**the GEORGE Hotel**  
7330 North Pima Road, Scottsdale, AZ 85258

1 REVISIONS MADE FOR CONNECTION BETWEEN GYM AND CAFE

### a3.4

CDS plan check numbers:  
Pre-Application Number: **430-PA-2021**  
**219-PA-2021**

**a6.8**

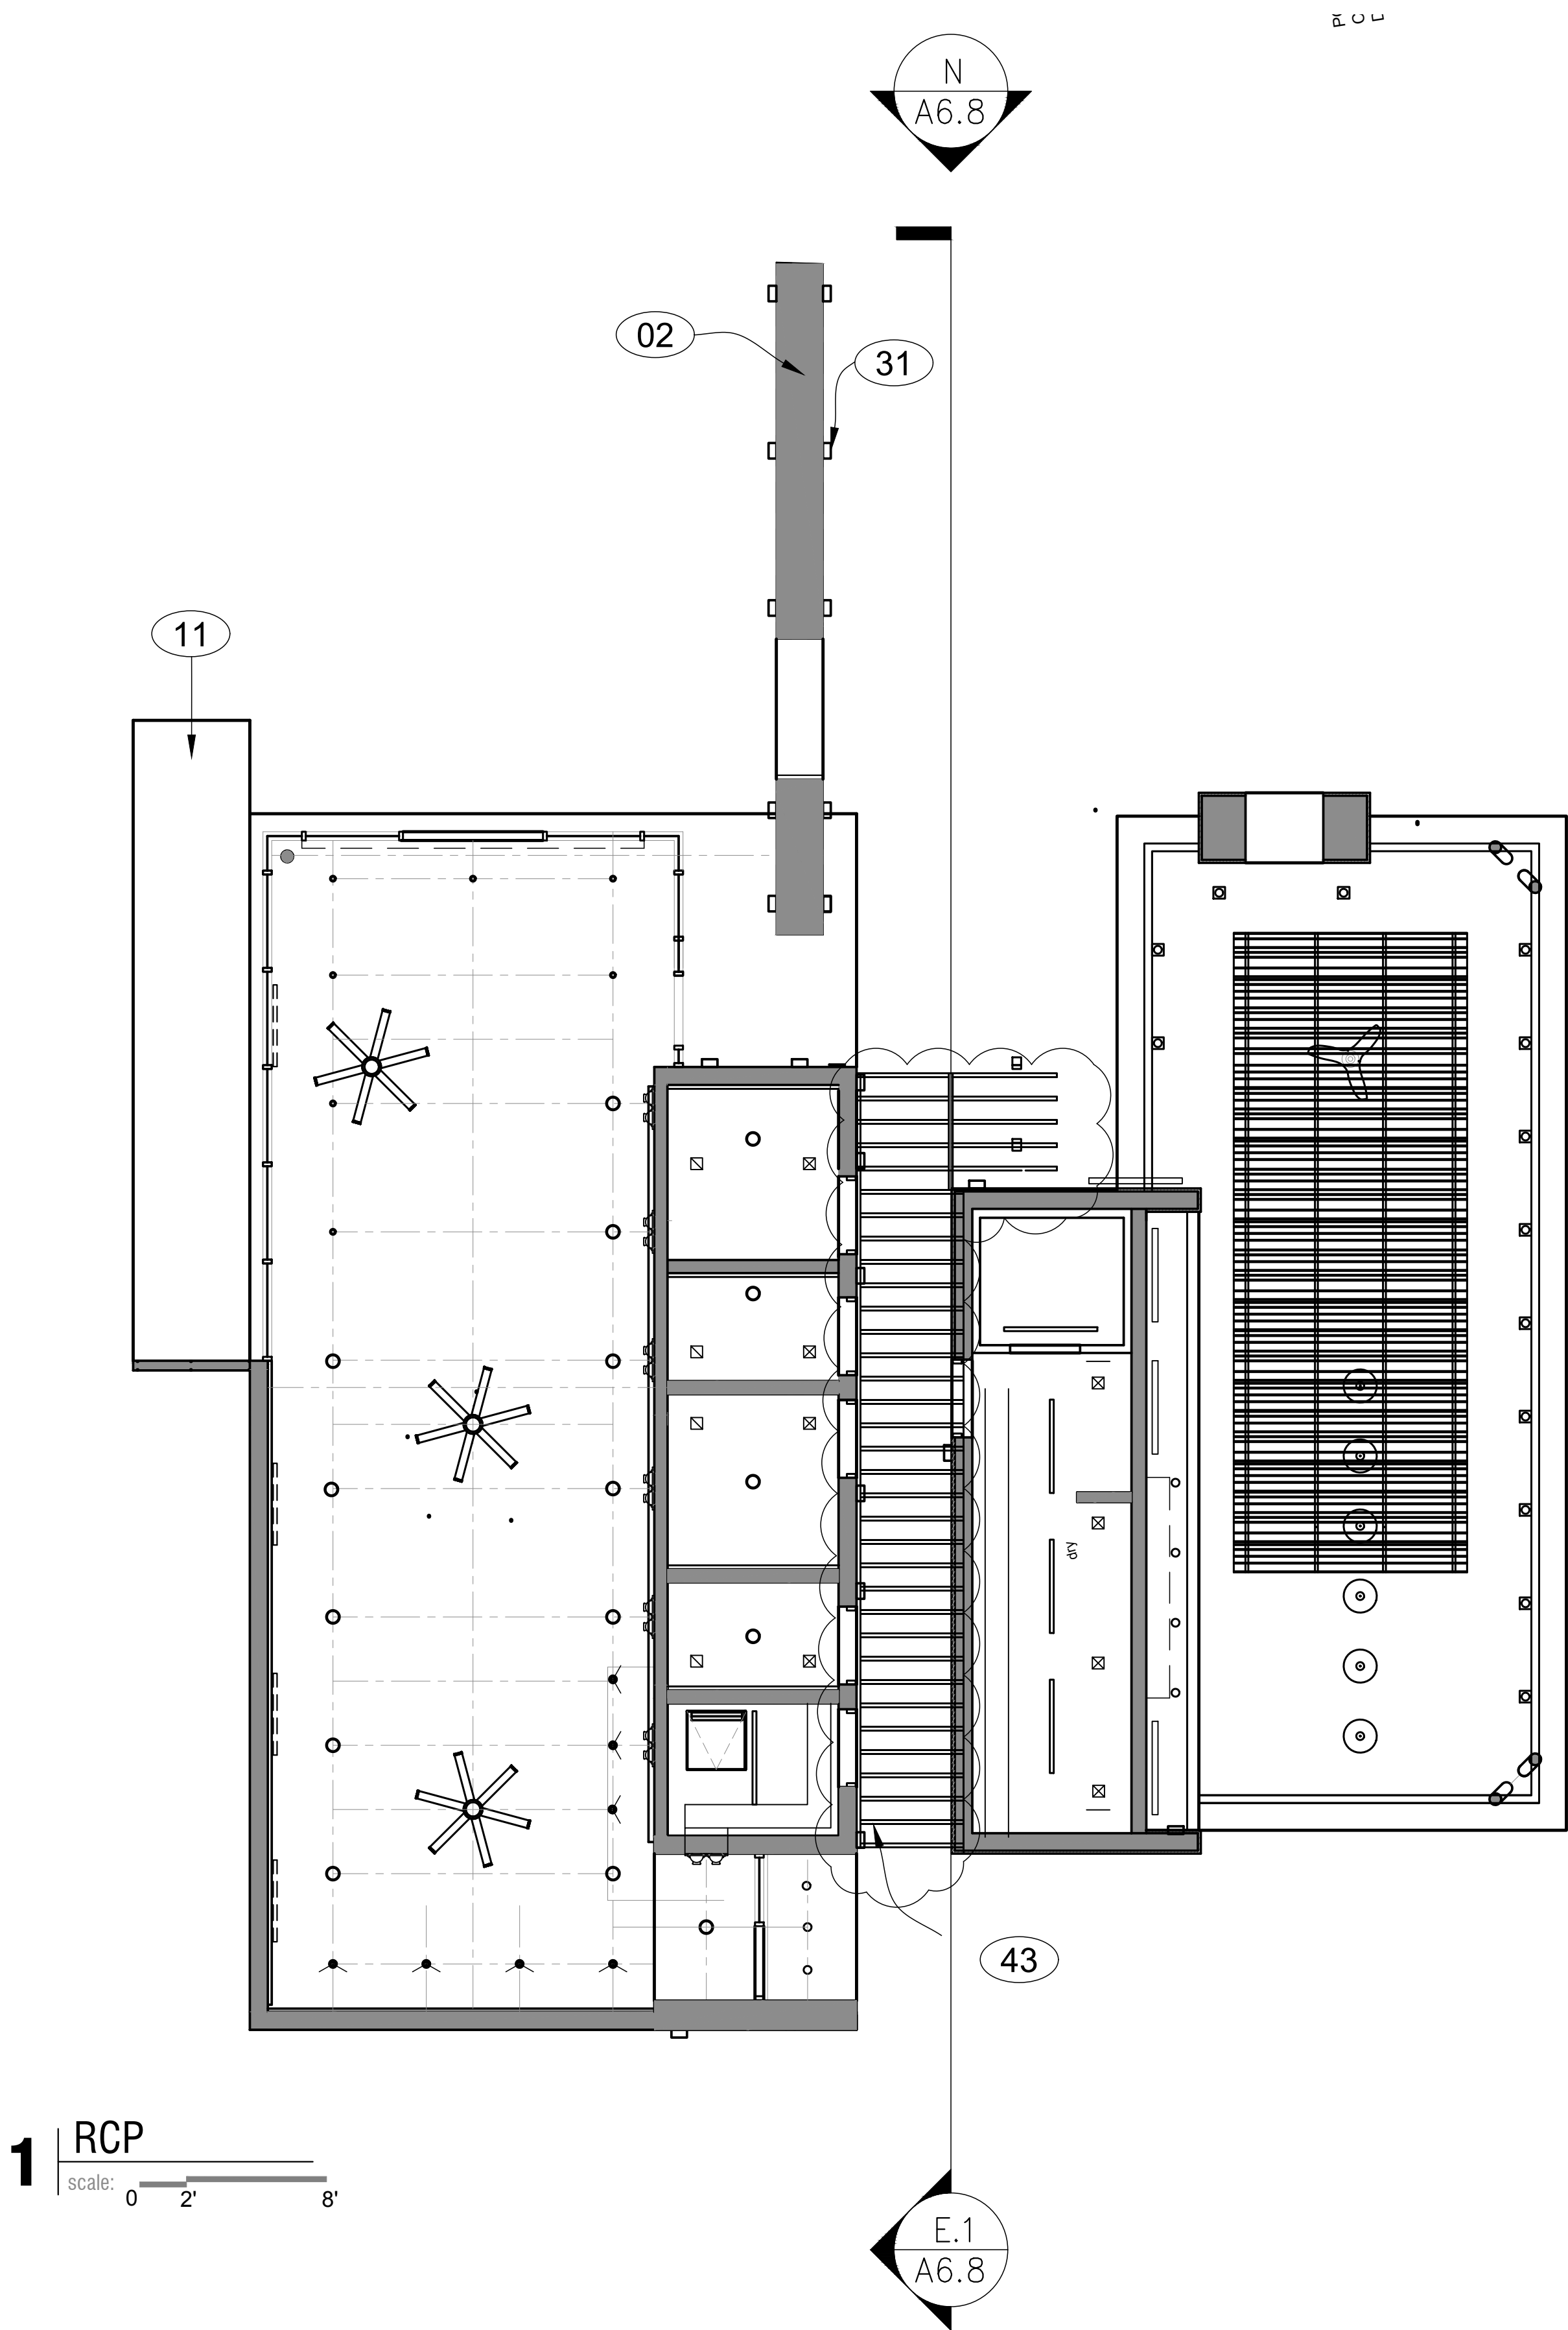
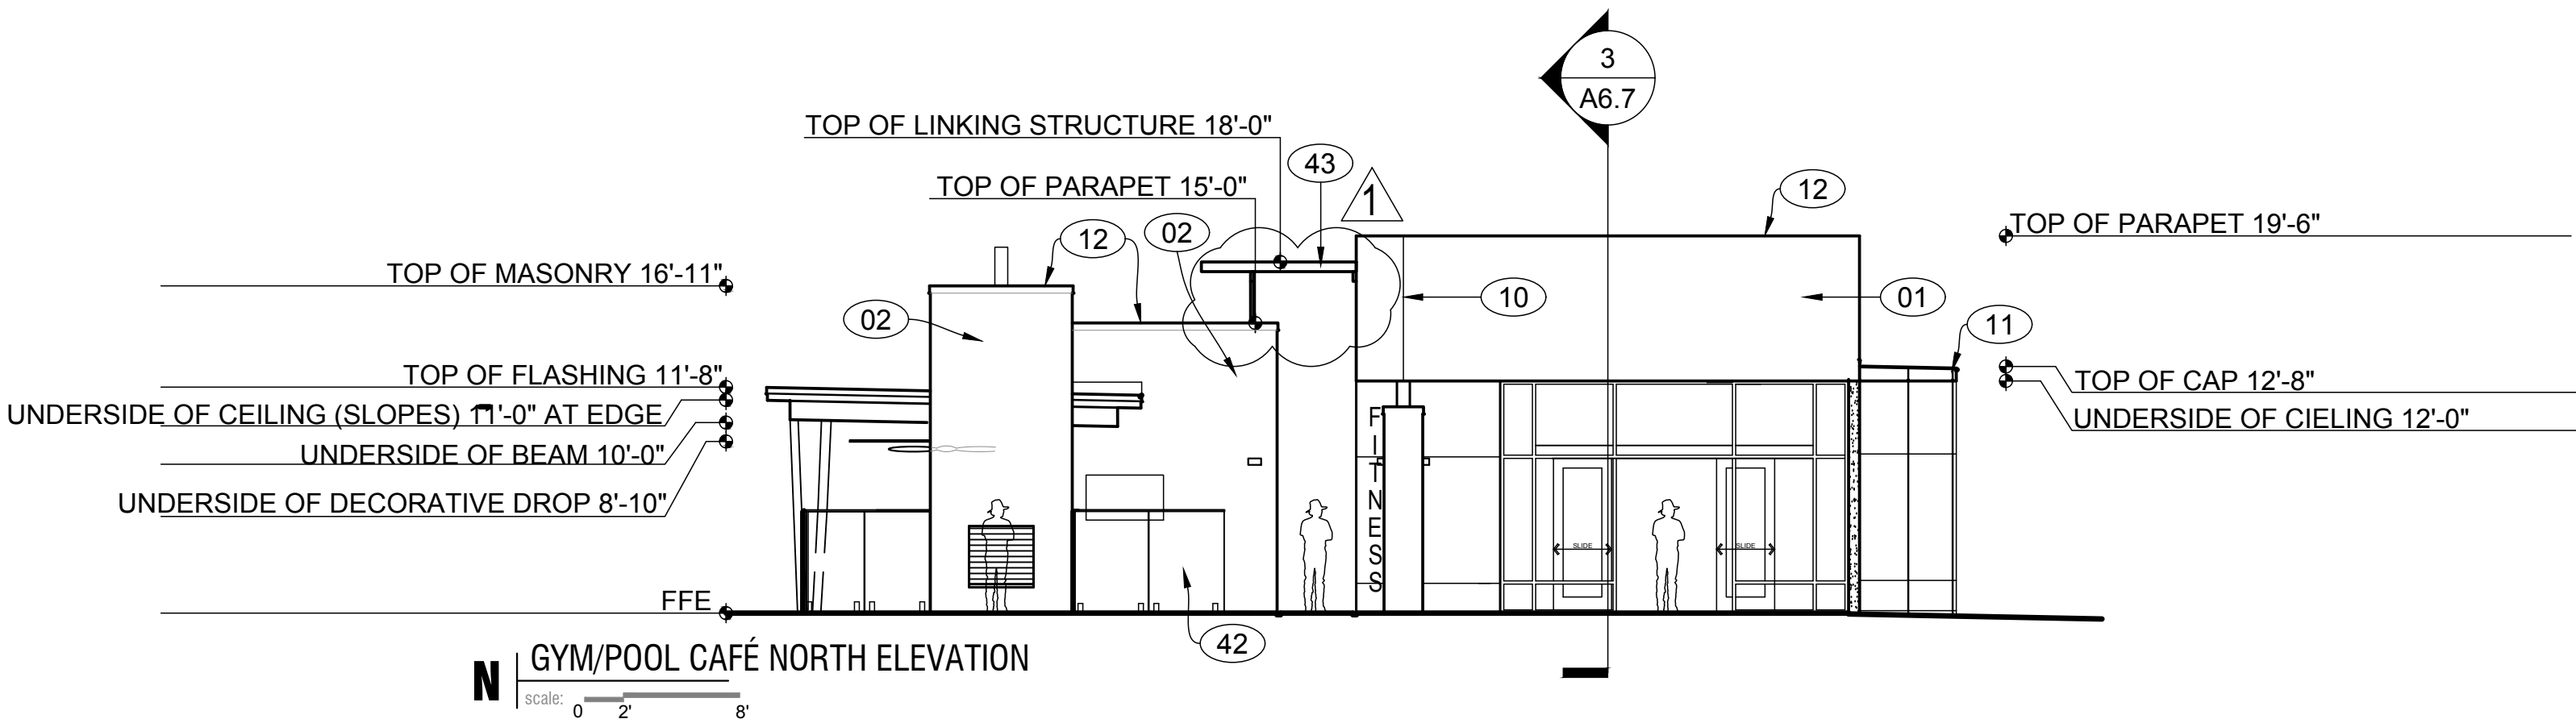
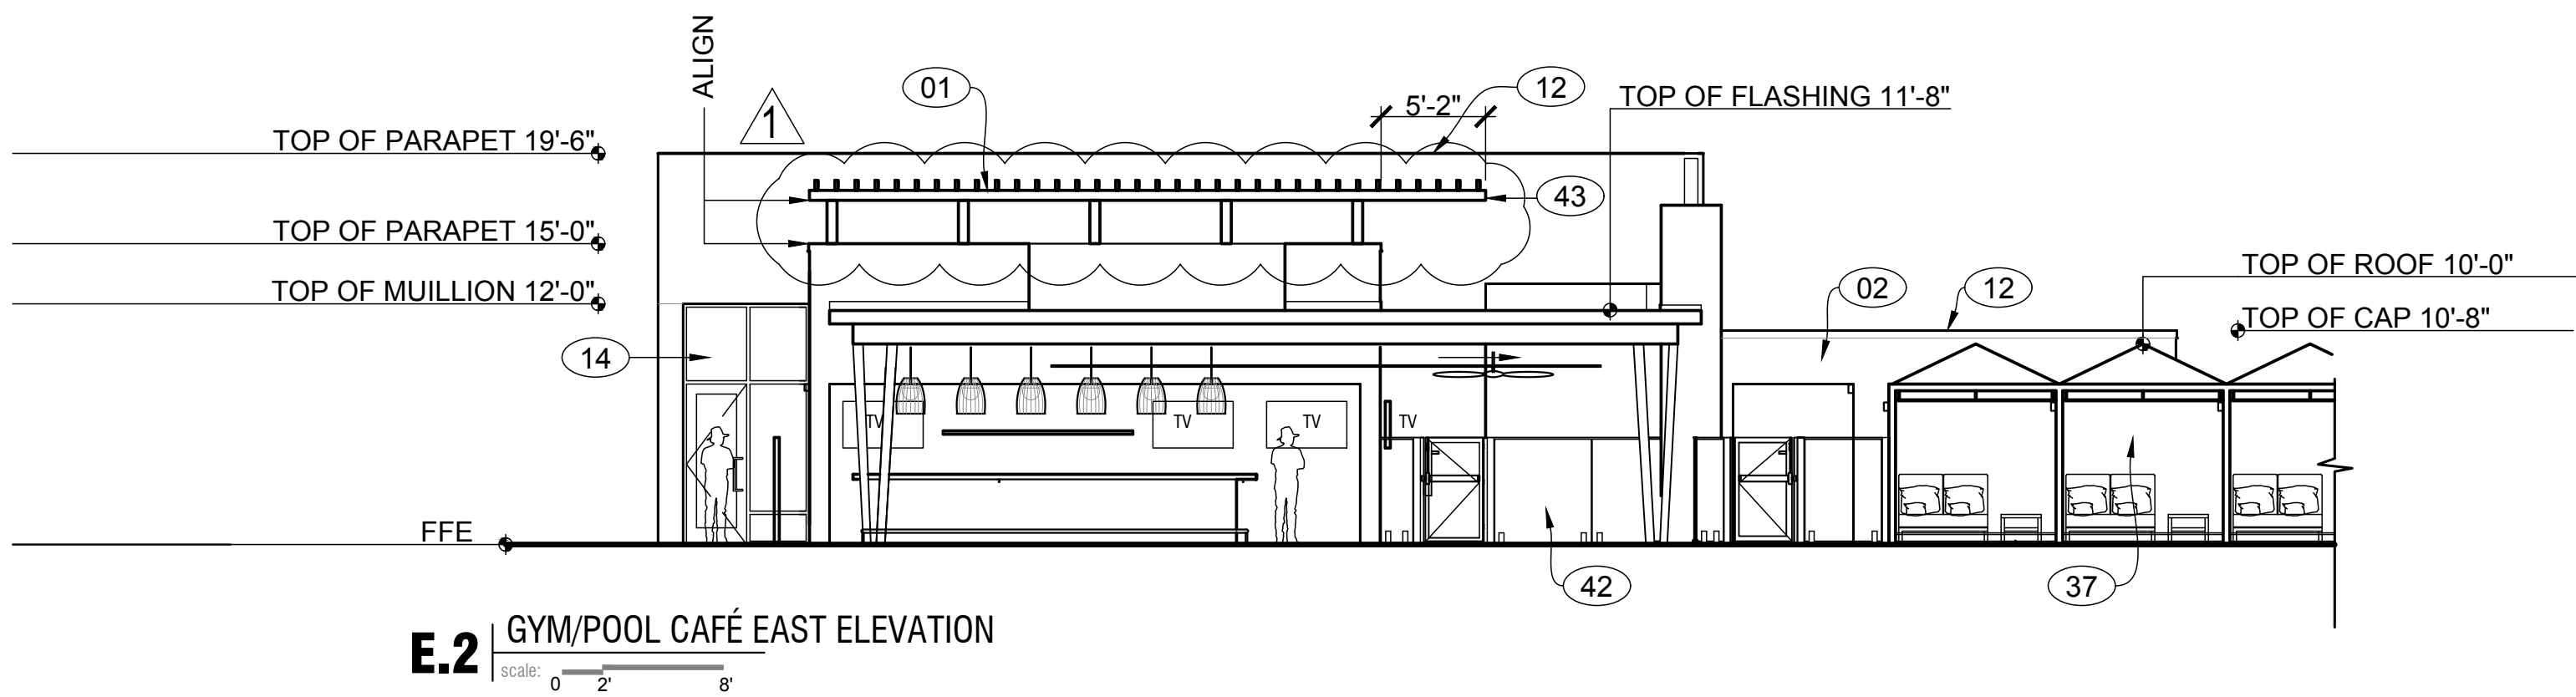
1 REVISIONS MADE FOR CONNECTION BETWEEN GYM AND CAFÉ
